ATTACHMENT 4

JH Rekker Consulting Ltd 16
December 2019: Response on
Hydrological Matters

RE CRC201366-8 Request for Further Information (RFI) – Response on Hydrological Matters

Figure 4: Location of mining related catchment flow divide shifts

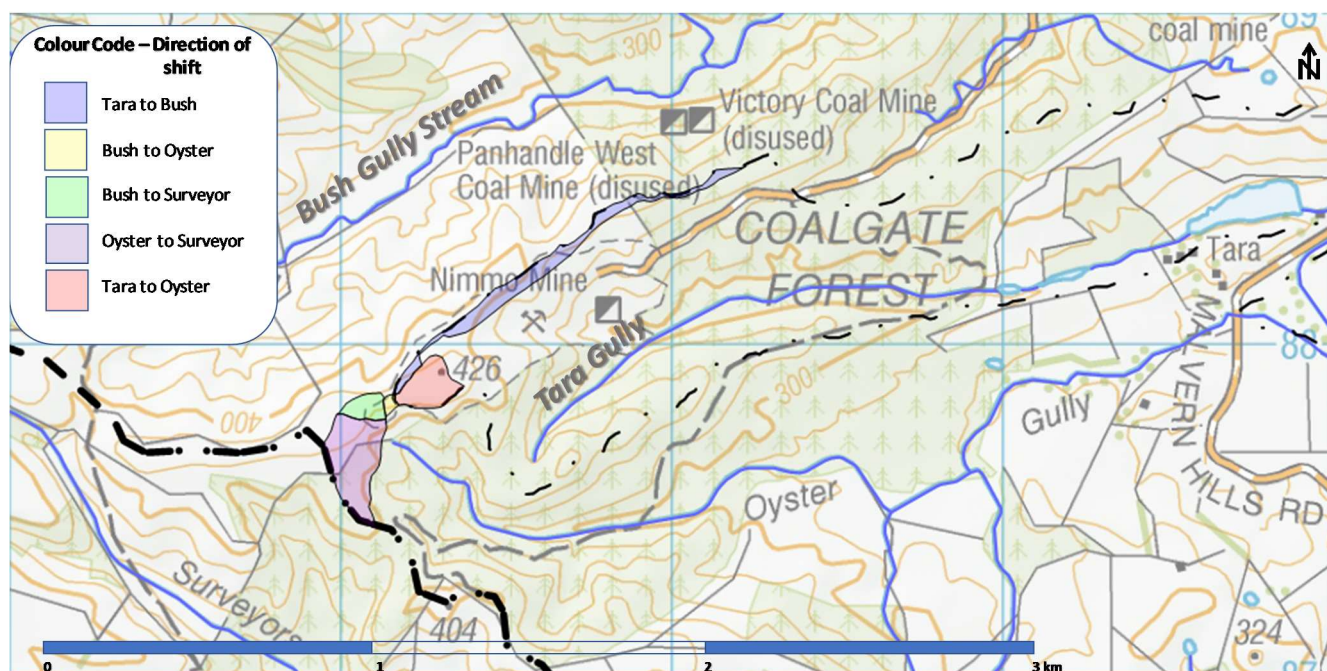
9. *An assessment of the effects on surface water flows (7dMALF and mean flows) in the Waianiwaniwa catchment and Selwyn River catchment. This assessment should consider the natural and post-mining topography, runoff co-efficients and meteorological conditions of the site and the influence of the water treatment system and take of water for dust suppression.*

10. Based on the assessment above and knowledge of the localised natural drainage of the site and surrounding area, please provide an assessment of potential effects of altering drainage patterns on any seepages or wetlands on the north-west slopes, the south-east gullies and Tara Stream and any subsequent changes in lows flows to receiving waterbodies. This assessment should identify any retrospective effects and future effects and also effects both inside and outside of the MOA.

One result of proposed mining earthworks referenced in application CRC201366-8 (“various consents to undertake mining activities at the Canterbury Coal Mine”), the operational and permanent sub-catchment divide positions will shift between the Bush Gully, Tara Gully, Oyster Gully and Surveyors Gully catchments. Slivers of land area will be traded between these sub-catchments. The Bush Gully and Surveyors Gully sub-catchments are net recipients of new catchment area, while Tara Gully and Oyster Gully are net losers of area. All sub-catchments rest within the Selwyn – Waihora Catchment and water management zone. However, Surveyors Gully flows into the Selwyn River near Glentunnel resulting in the loss of land from adjoining catchments that previously drained to the Waianiwaniwa River. There is thus a net shift from the Waianiwaniwa sub-catchment to the Selwyn main stem catchment amounting to 4.78 ha.

The Bush Gully and Surveyors Gully sub-catchments are net recipients of new catchment area, while Tara Gully and Oyster Gully are net losers of area. All sub-catchments rest within the Selwyn – Waihora Catchment and water management zone. However, Surveyors Gully flows into the Selwyn River near Glentunnel resulting in the loss of land from adjoining catchments that previously drained to the Waianiwaniwa River. There is thus a net shift from the Waianiwaniwa sub-catchment to the Selwyn main stem catchment amounting to 4.78 ha.

Methodologically, this entailed interrogating the contoured surfaces of mean and mean annual low flow shown in Figure 1 and Figure 2 within the sub-catchment shift areas shown in Figure 4. A sample 'cloud' of points within each zone was synthesised and values of flow statistics were generated for each point within the cloud. The returned values were averaged for each distinct zone and tabulated in Table 2.

Referring to Table 2 it is possible to ascertain that the Selwyn River main stem at Glentunnel receives additional mean flow and MALF_{7d} of 0.021 L/s from Surveyors Gully as a result of sub-catchment shifts in the CCM mine operational area. Mean flow and MALF_{7d} in the Selwyn River at Whitecliffs (immediately upstream of Glentunnel) are 3,236 and 792 L/s, respectively. Bush Gully benefits from an additional 0.01 L/s by the same mechanism, at the expense of Tara and Oyster gullies. Mean flow and MALF_{7d} in the Waianiwaniwa River at the Bush Gully Stream confluence are estimated as 17.4 and 155 L/s, respectively. Hence, sub-catchment shifts would have a larger depleting effect on the Waianiwaniwa River than the compensating effect of increased flow on the Selwyn River main stem. The effects on the two sub-catchments is shown in context in Table 3.

The overall greatest magnitude of effect from the sub-catchment shifts would be a diminution in MALF_{7d} of the Waianiwaniwa River of 0.021 L/s (1.8 m³/d) or 0.12%. Such flow effects are beyond the limits of detection for modern flow gauging (typically ± 5%) and negligible in terms of any change in habitat conditions for aquatic organisms.

Figure 5: Location map of wetlands identified within the Boffa Miskell ecological mapping inside Mine Operations Area

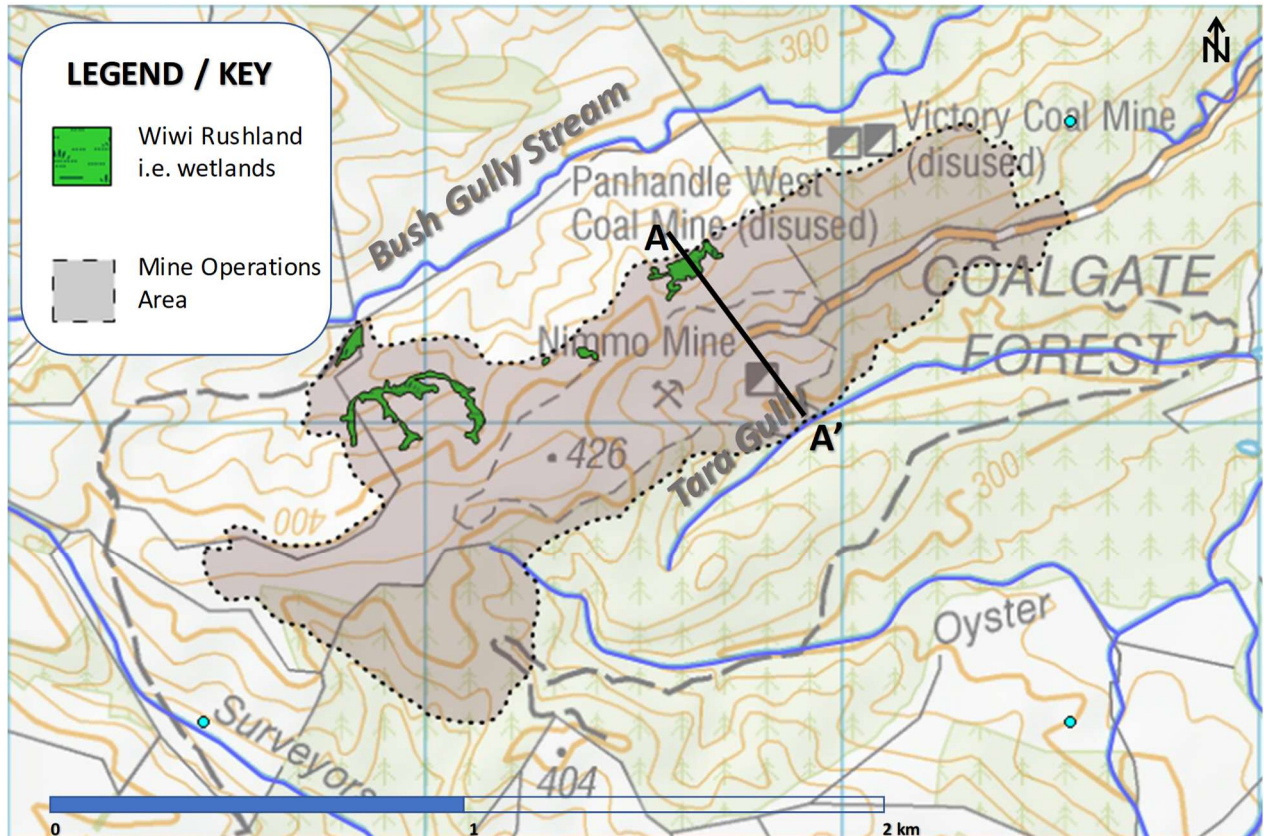
2. *Using the map and information in response to question 10, an assessment of the potential ecological effects on seeps/wetlands and a description of any measures to avoid, remedy, mitigate or offset adverse effects.*

Boffa Miskell terrestrial ecologists identified one such class of wetlands as 'wiwi rushland', essentially wiwi rushes that have colonised areas of water seepage on the north-western slopes of the mine operations area. Figure 5 maps the distribution of wiwi rushland that is an analogue for seepage wetlands within the mine operations area. These wetlands are located on the mid and lower slopes of the ridge flank draining to Bush Gully Stream.
